## **NISTUNE TECHNICAL BULLETIN #002**

### **TITLE : Correction of ECU Air Flow Meter modifications**

**Models covered: CR31 RB30E, VLT RB30ET, Z31 VG30E/ET (1986-1987)**

**Date: 25 September 2009**

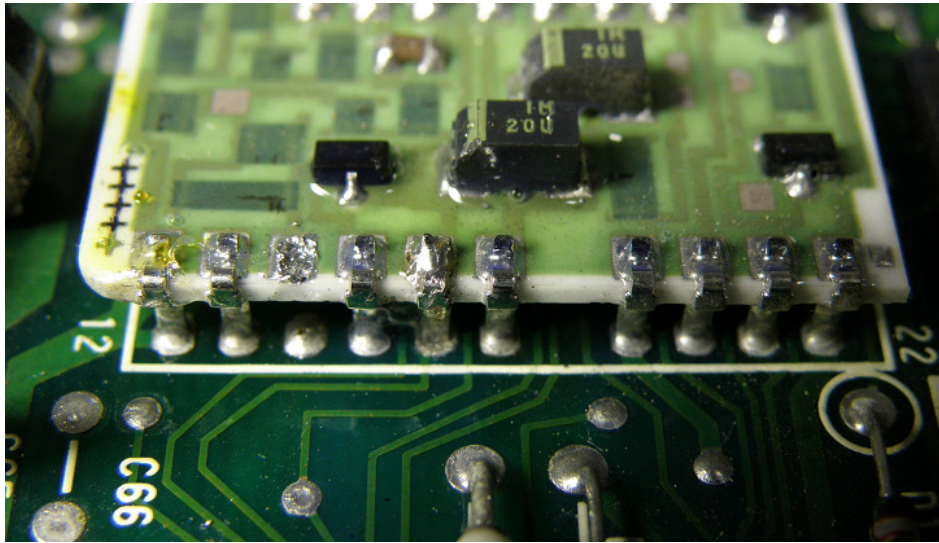
Following this modification it has been noticed during field testing that logs have indicated that 0 and 5 volt spikes in the AFM signal received by the HD46510 chip have been received and processed as can be seen below:

The removal of the opamp from the circuit has affected filtering of the ECU and occasional spikes in the fuel injection could be potentially noticed. In the log above TP was not affected, so the map points accessed were not changed.

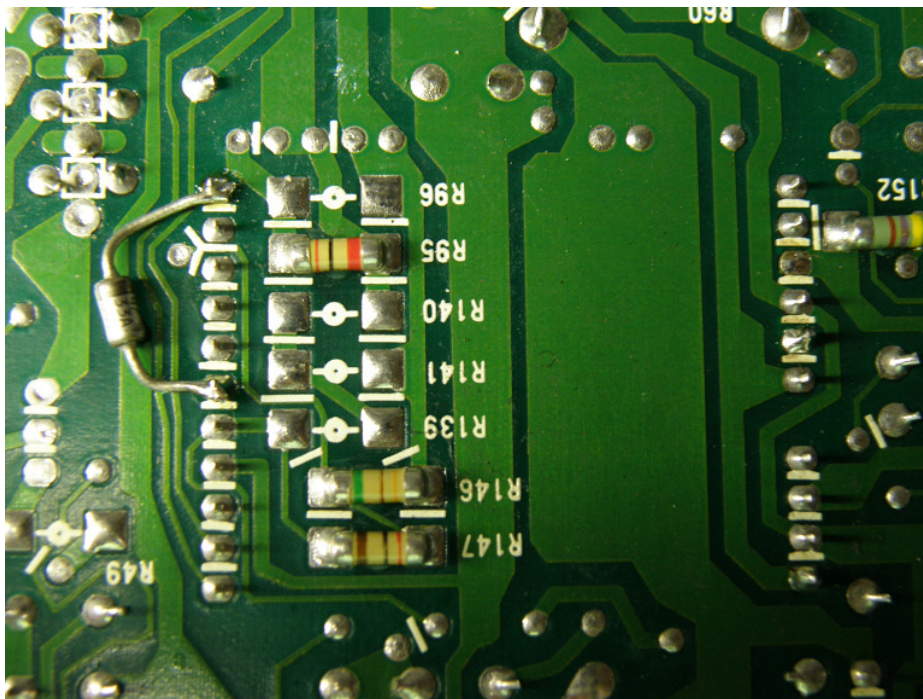
1. Remove pin 14 from the omp amp board (this is two pins up from pin 12 marked at the end)

2. Using a zener diode is still recommended as the opamp may not protect against over voltage from the AFM if it occurs. It will need to be moved to the input side of the ECU

Solder the banded end of the zener diode to pin 11, and the other end to pin 6 as pictured below.

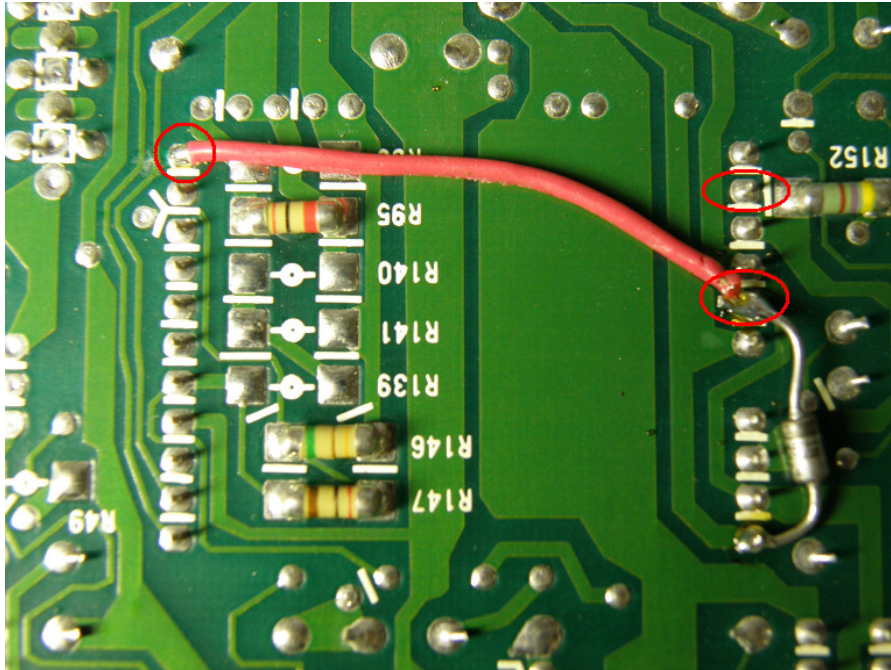
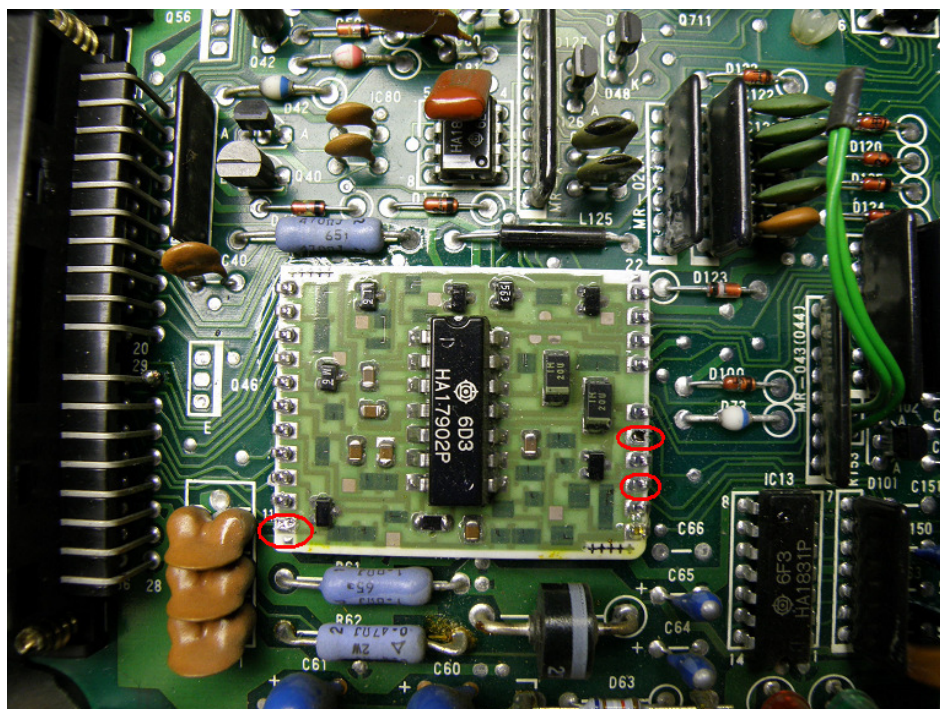
1. On the reverse side of the ECU desolder and remove the installed wire jumper and zener diode
2. Desolder the holes which are highlighted by the red circles in the diagram

3. Remove Pin 14 (lower RHS) from the board and move to previously removed Pin 16 (upper RHS) and solder in. Reinstall Pin 11 (lower LHS) to the board using jumper wire or similar.

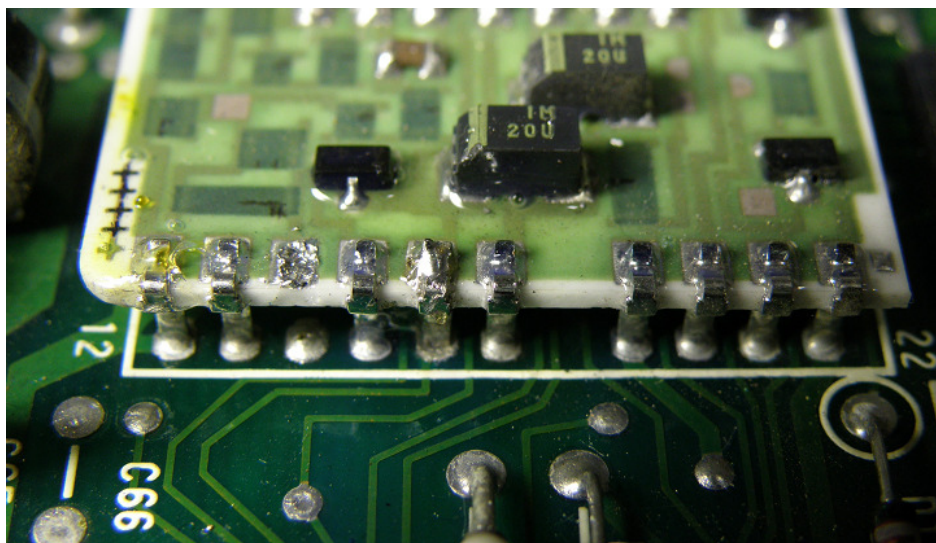
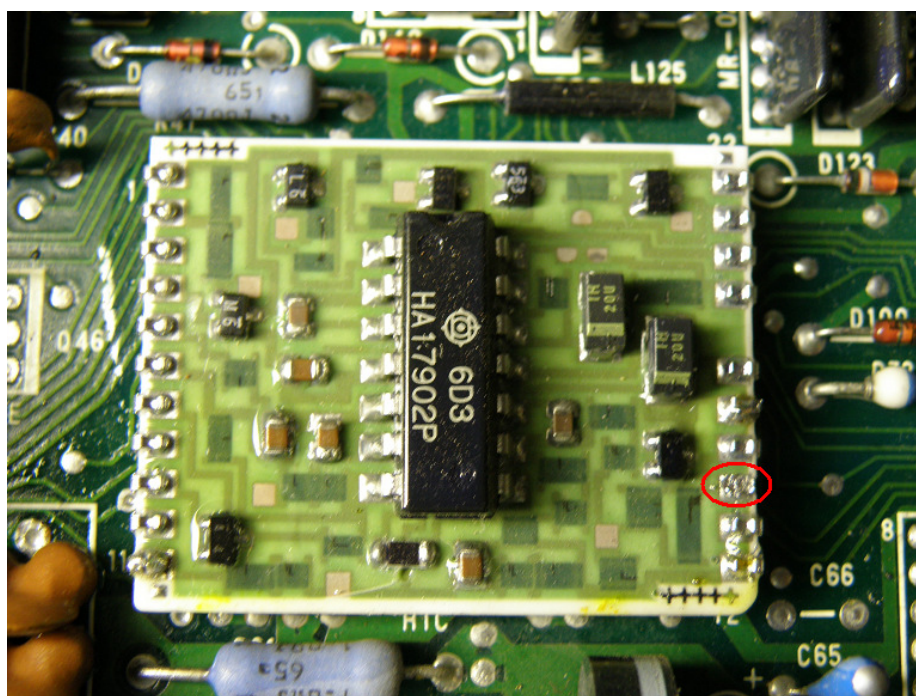
4. Now the circuit board should look like the picture below. Both pin 11 and pin 16 have been resoldered and pin 14 (highlighted) is now removed

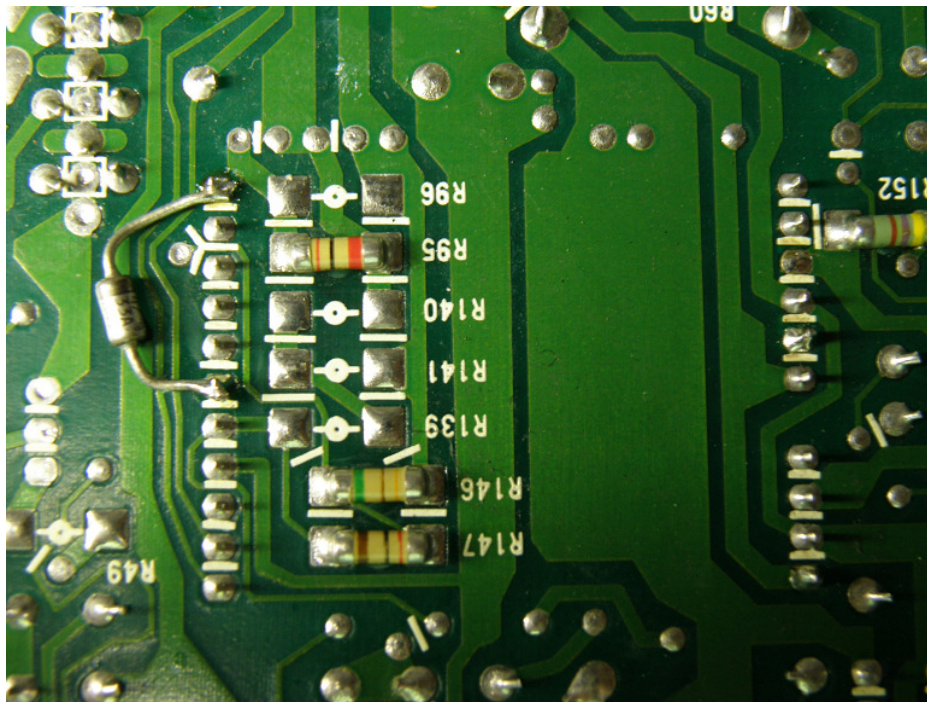
5. Retaining the zener diode is still recommended, as the opamp may not protect against over voltage from the AFM if it occurs. It will need to be moved to the input side of the ECU

Solder the banded end of the zener diode to pin 11, and the other end to pin 6 as pictured below.
